ADDENDUM No. 3
FOR
LINK – Multi-Use Development
BID PACKAGE – All Trades

Date of Issue: April 24, 2023

LINK – Addendum #3 Narrative

4/21/23

6 STAIR 2 - FIFTH FLOOR PLAN
1/4" = 1'-0" REFERENCE: 1/A505A

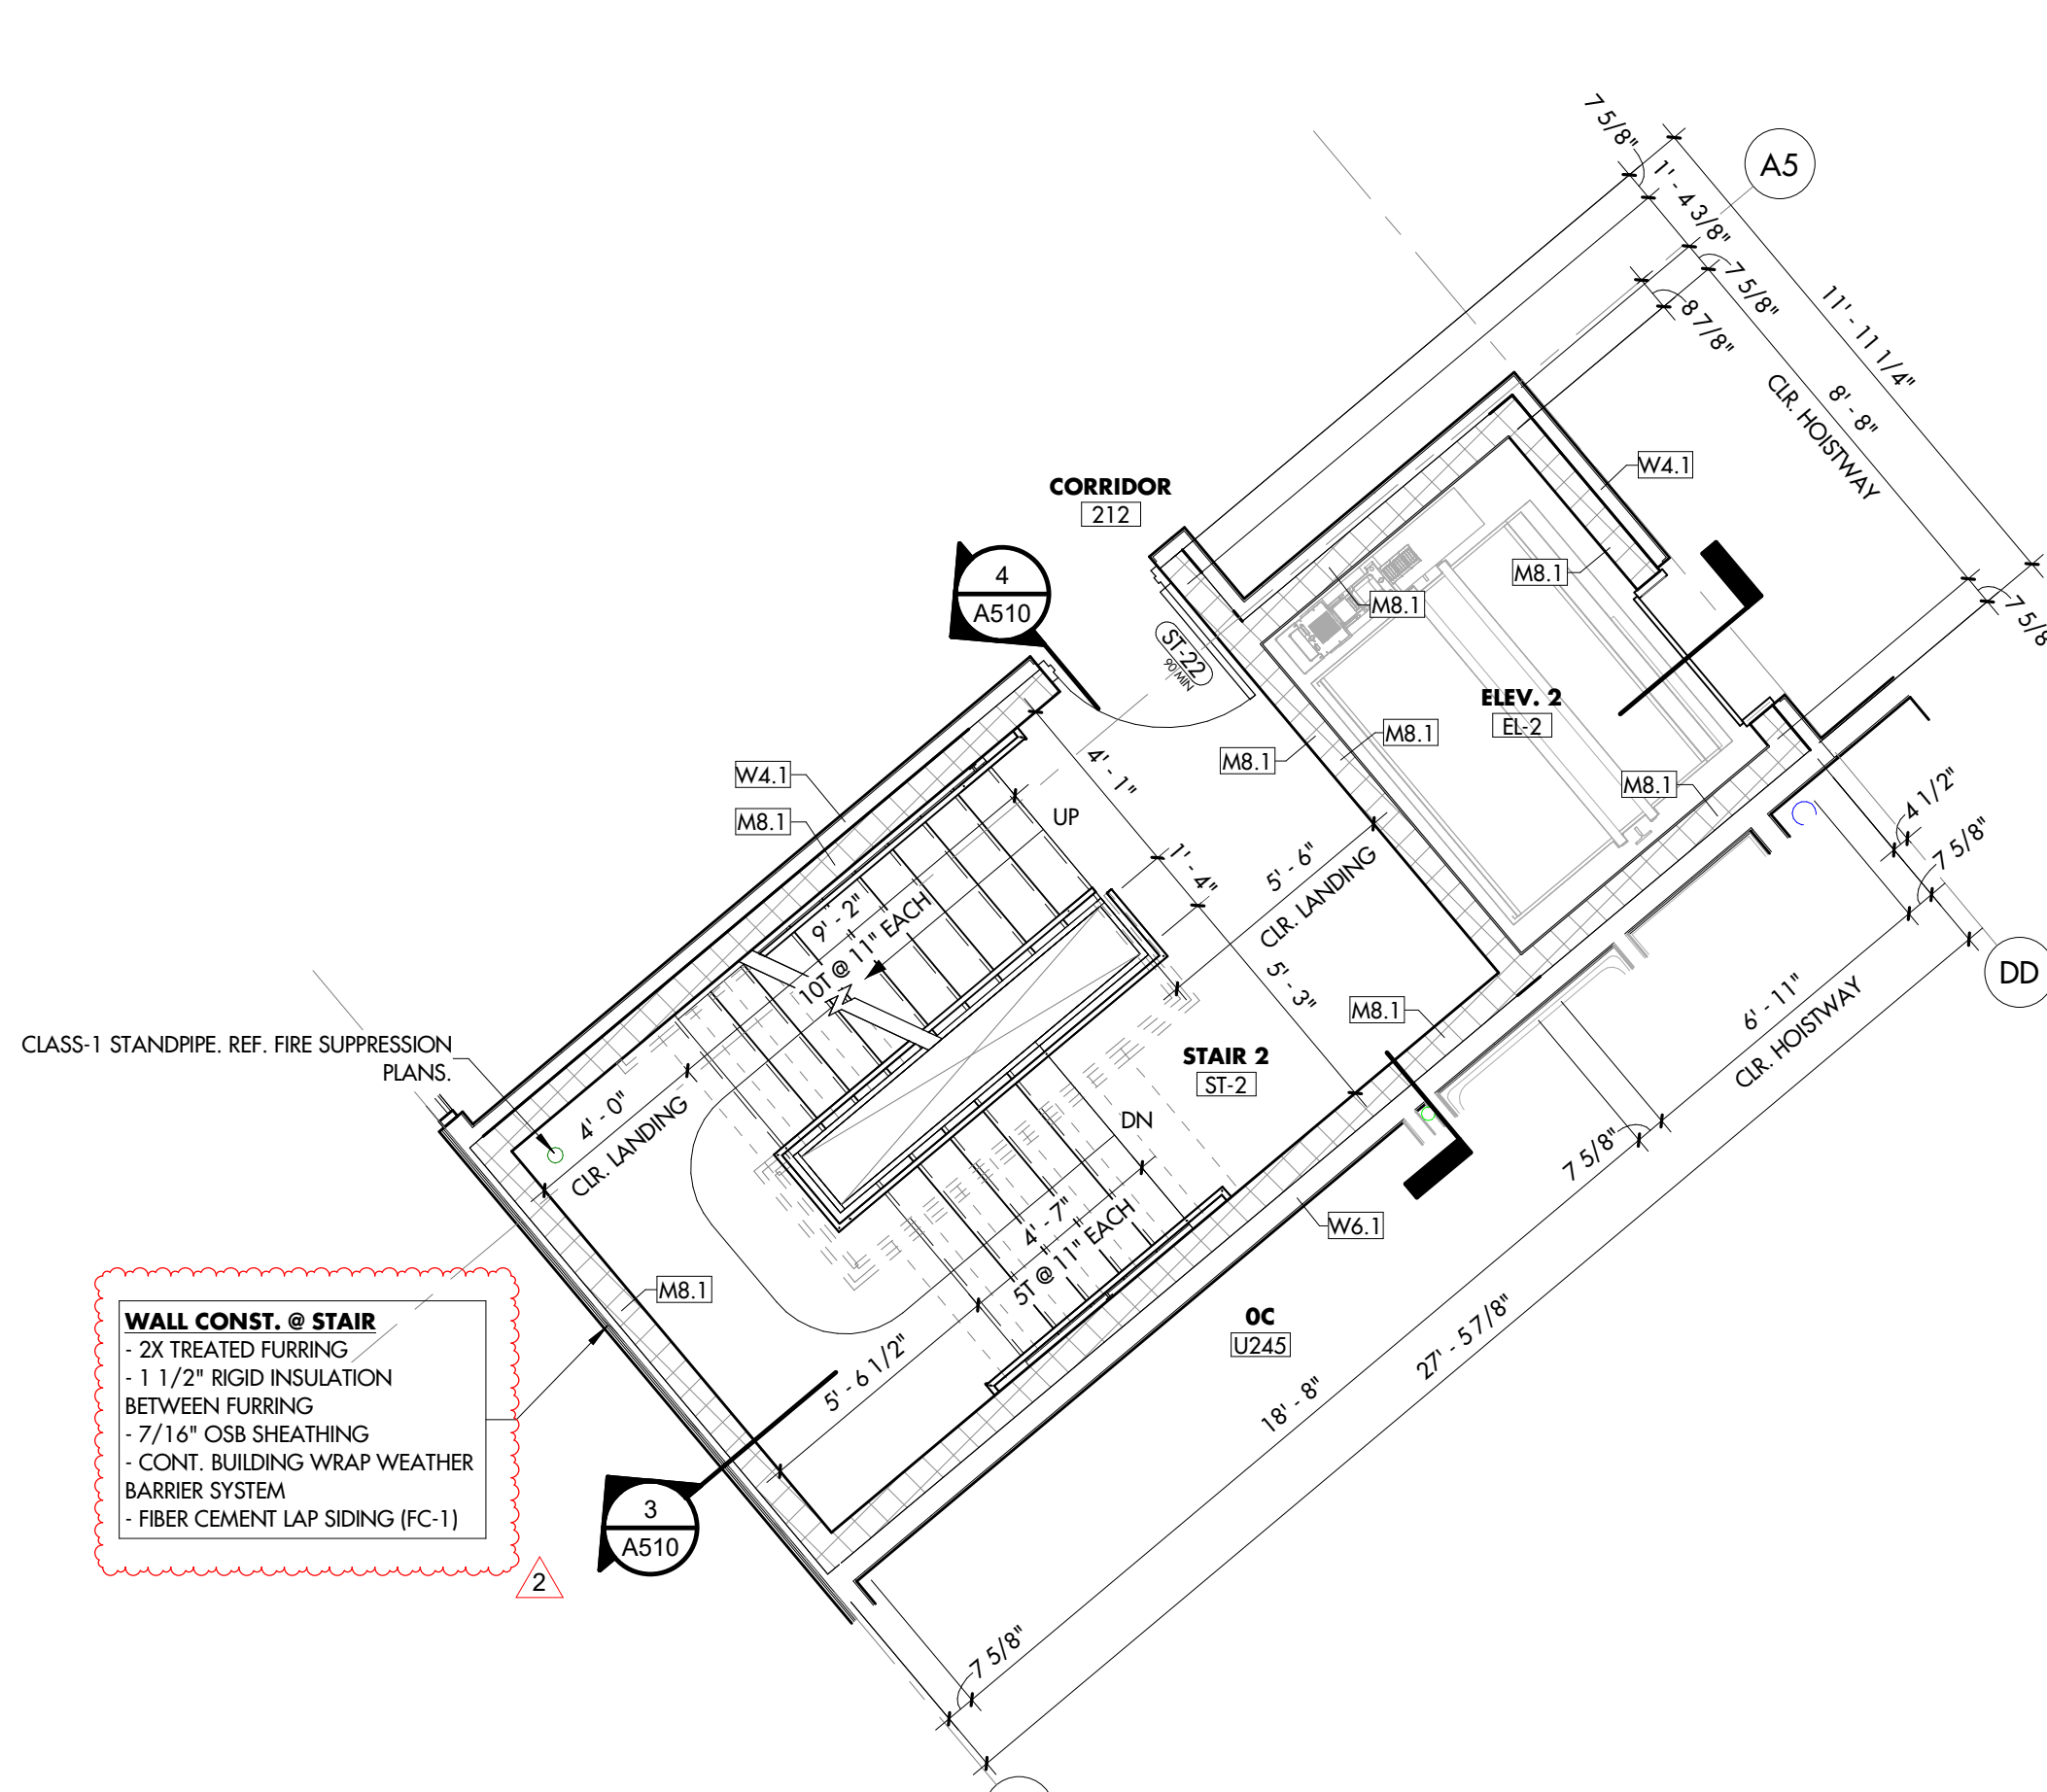
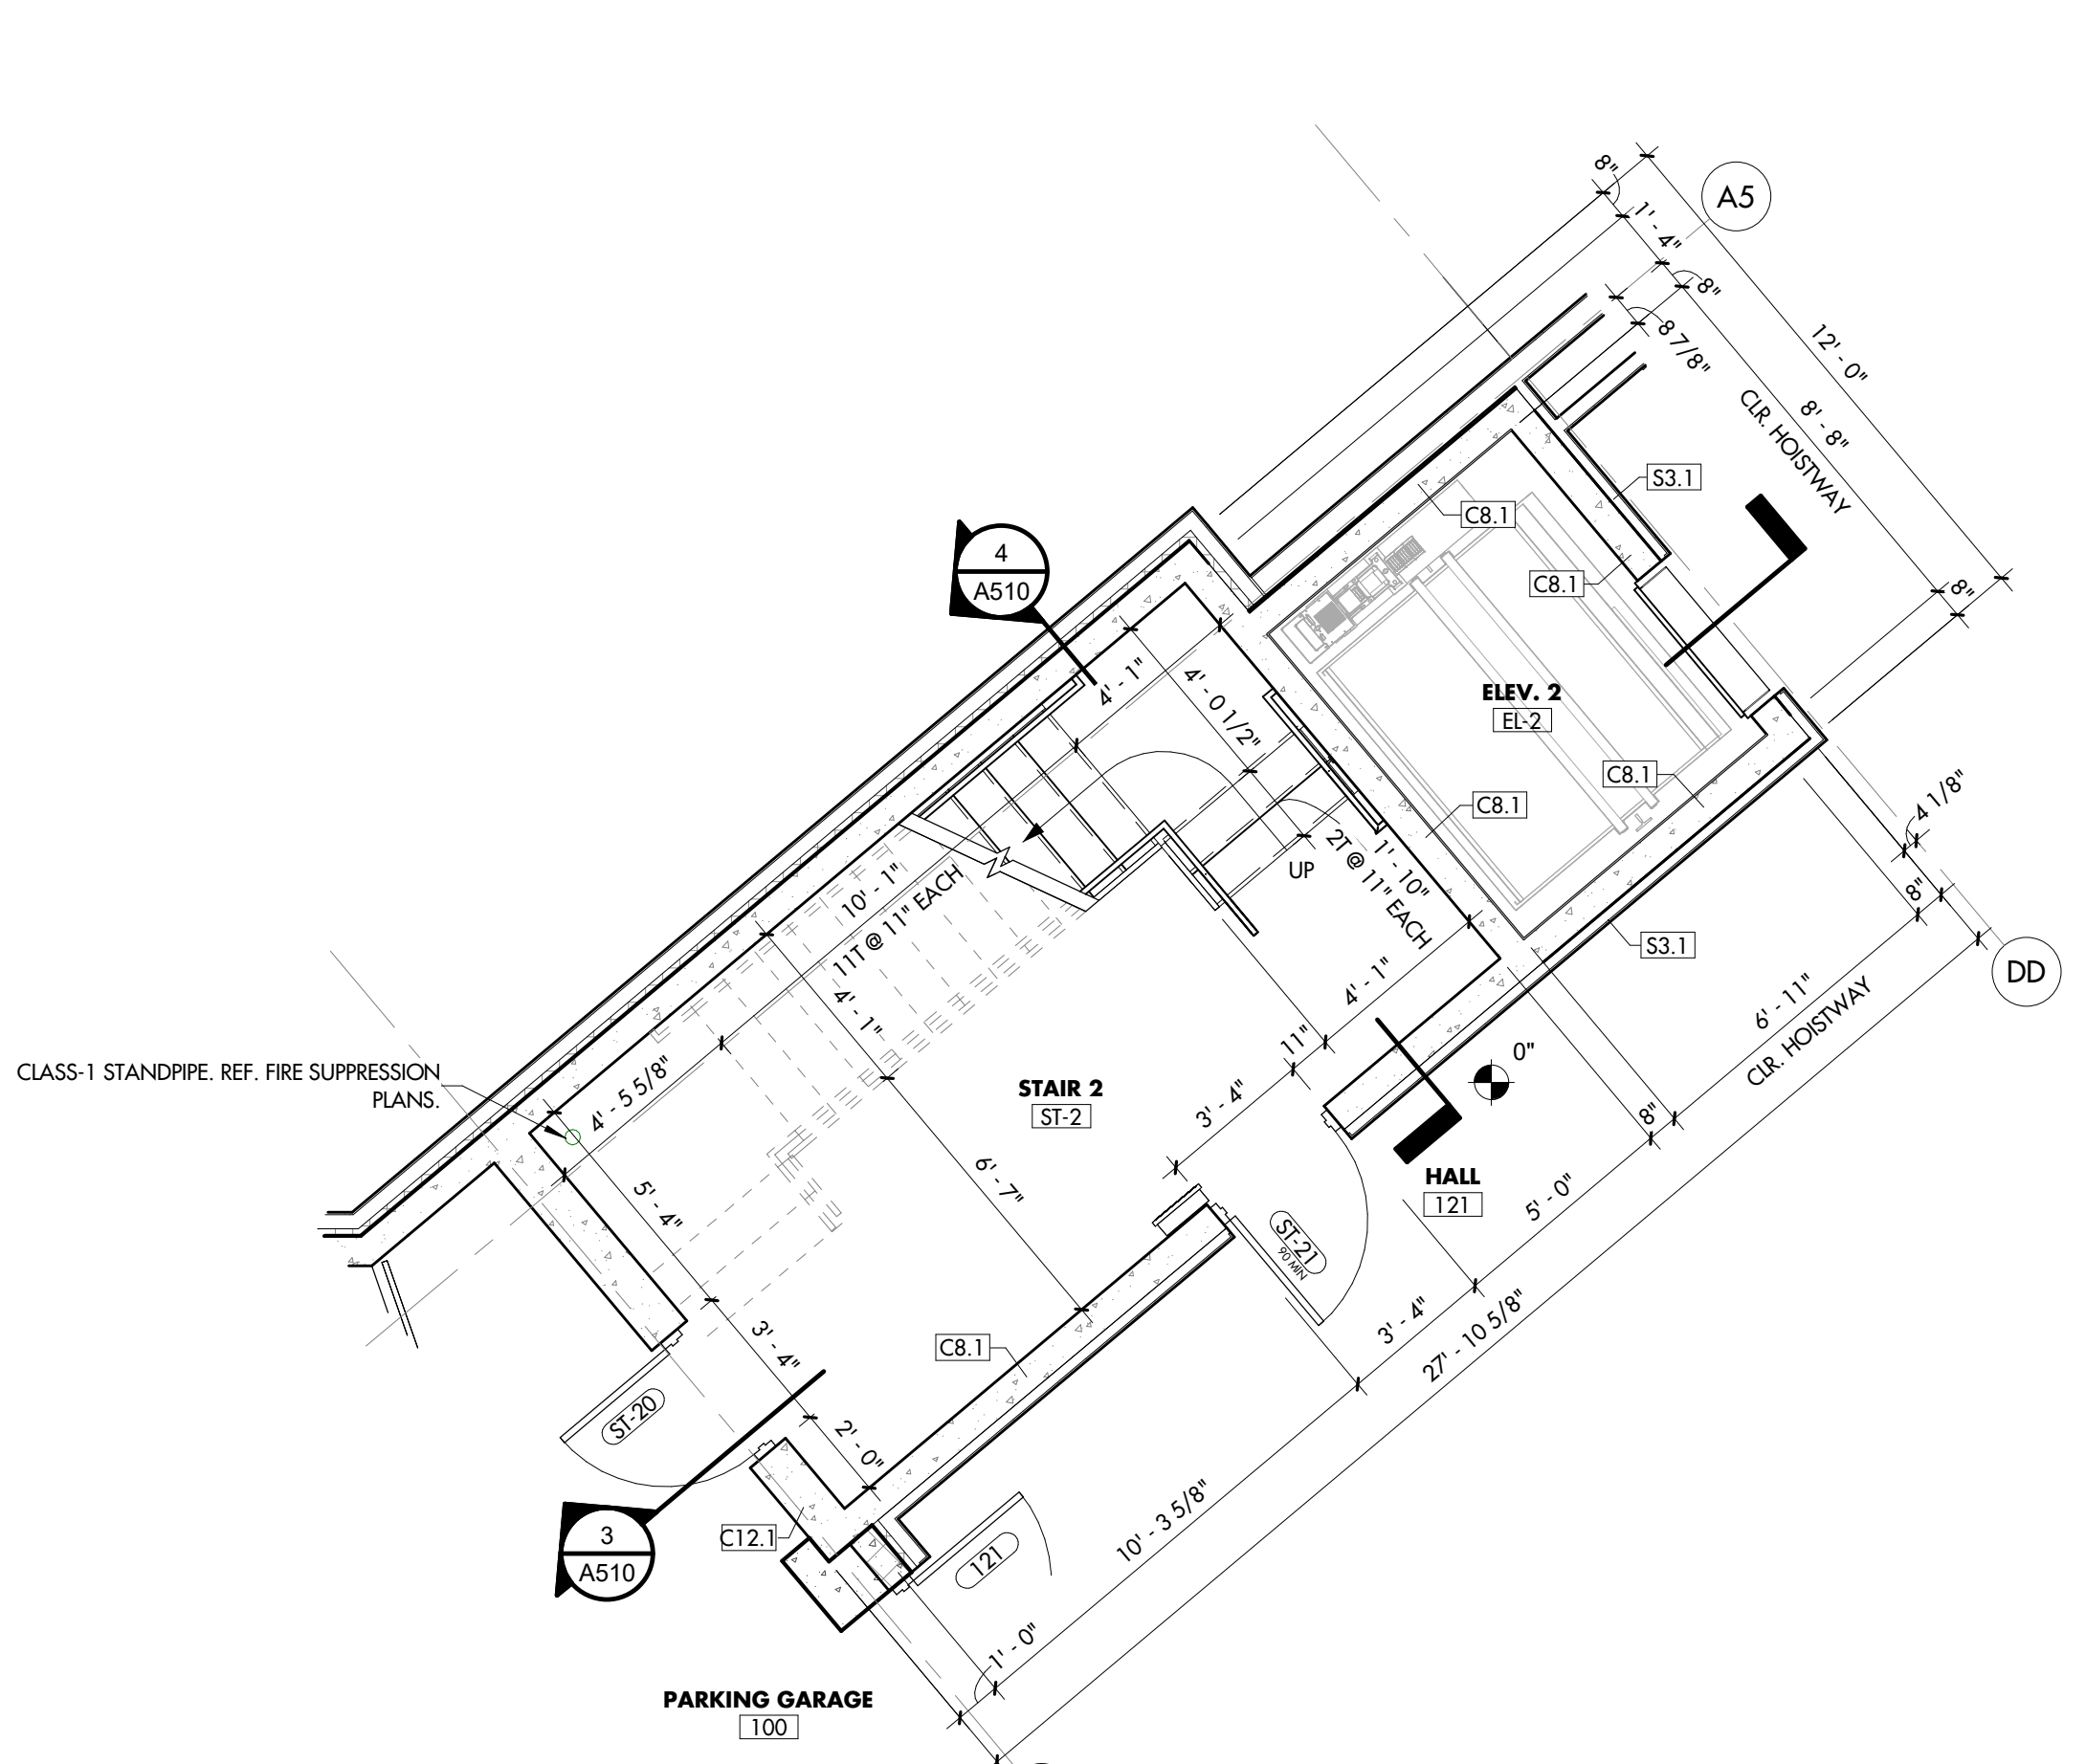
- A504
 - Clarified exterior wall construction at stair.
- A601
 - Revised door finishes.
- A602
 - Revised door finishes.
 - Revised pre-hung unit door heights.
